ADDENDUM No. 1

RFP No. 26-47

PARKS POOL LINING

Site: VETERANS MEMORIAL PARK POOL- ANN ARBOR, MI		
Title: NEW PROPOSED SIDE WALL MAIN DRAINS- SLIDE		
Date: 3-23-26	Scale: 1/4" = 1'-0"	SP-1 sheet
Drawn by: NJS	Rev:

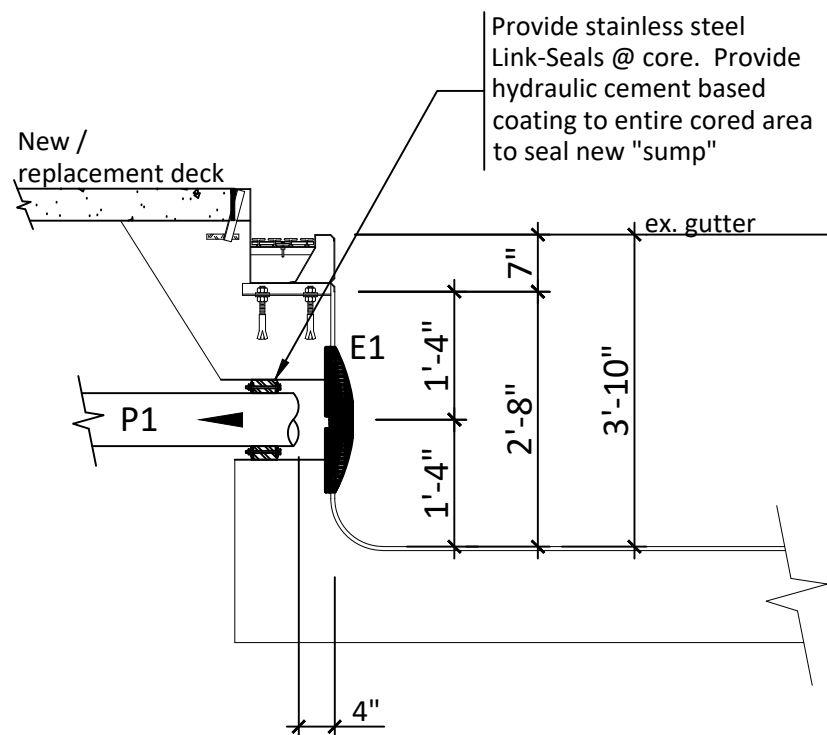
- Question 6: Are there any other projects at the pools that may impact the lining work?
Answer 6: Yes, there is planned work at Veterans Memorial Park Pool to change the side wall main drains. This project is expected to be completed prior to lining work beginning. A copy of the proposed plans has been included in this addendum.

Project scope is to remove the over the beam slide suction and place it underground. This is to include installation of new schedule 80 PVC plumbing connected to existing strainer, pump and discharge plumbing which are to remain intact.

Install a flow meter as indicated so facility can operate the pump and slide at a max discharge rate of 450 GPM

Patch and repair deck concrete as indicated

Equipment Schedule		
Tag	Description	Qty.
E1	Provide and install new VGBA compliant grates and frames by Neptune Benson. Lawson 18" x 18" grates installed in a wall application. Provide 10" cores, link seals and waterproofing for sump. Install frames in wall so that the liner may be patched and made water tight by the liner contractor	2
